V8 XJ Series/XK

600-03

**Part-Load Engine Breather – Partial Blockage  
of Restrictor – Scheduled Cleaning –  
Service Action S474**

**MODEL**  
1997-2001 MY XK Range  
1998-2001 MY V8 XJ Series  
**VIN**  
001001-A13614  
812256-F25708

ILLUSTRATION 1

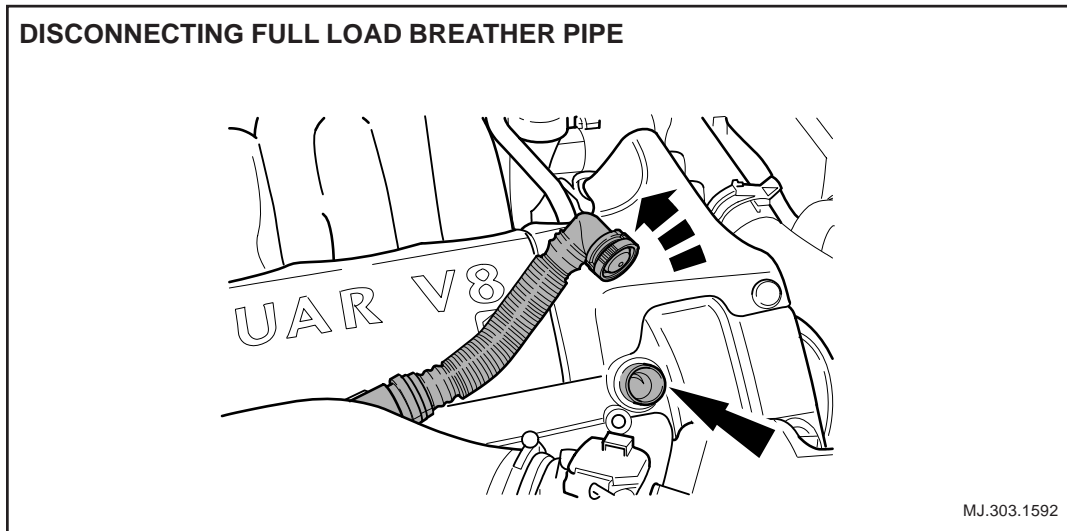
1. Open the hood. Cover the fenders with protective fender covers.
2. On normally aspirated engines, remove the engine cover from the left cylinder bank.
3. Start the engine.
4. Disconnect the full load breather line on the right camshaft cover, (Illustration 1).

ILLUSTRATION 2

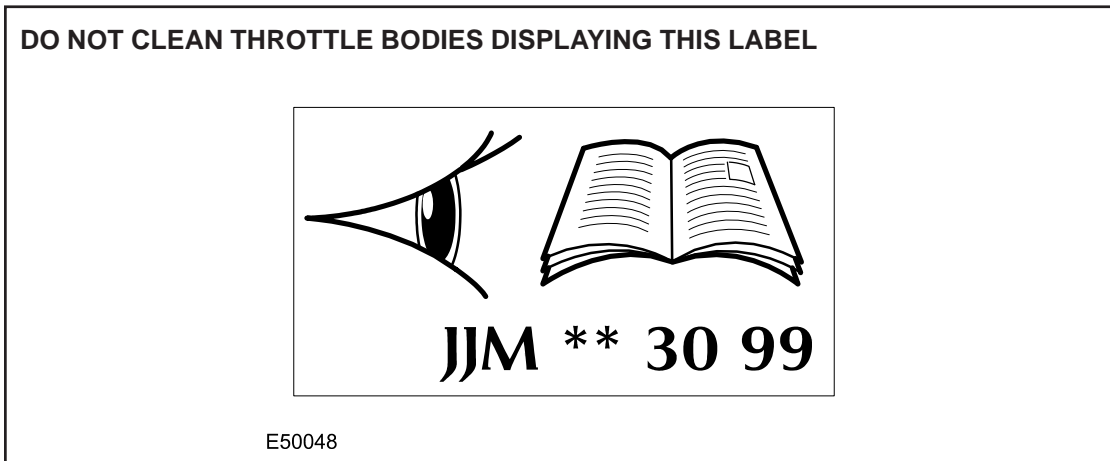
**⚠ Caution:** If the throttle body displays the label shown in Illustration 2, do not clean the throttle body bore and butterfly valve as damage to the vehicle can result.

ILLUSTRATION 3

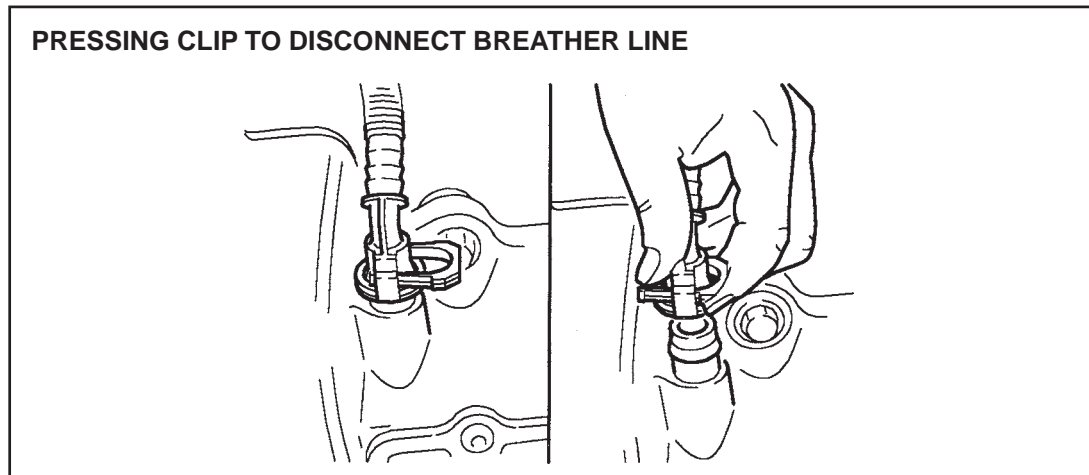
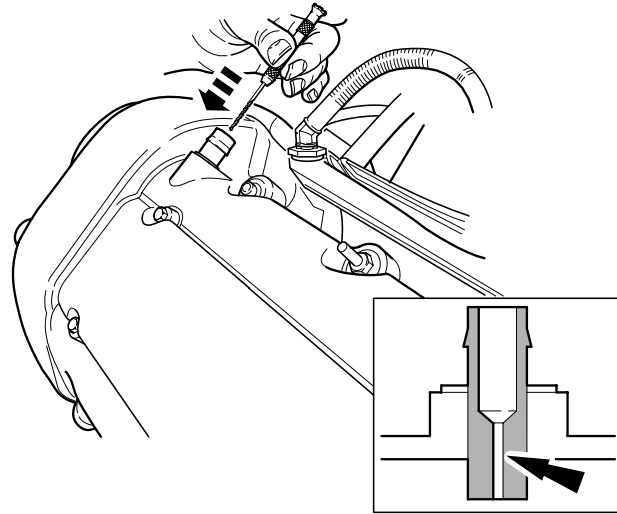
6. Depress the retaining clip (Illustration 3) of the connector of the part-load breather line, allowing the line connector to be disconnected from the breather stub on the left camshaft cover.
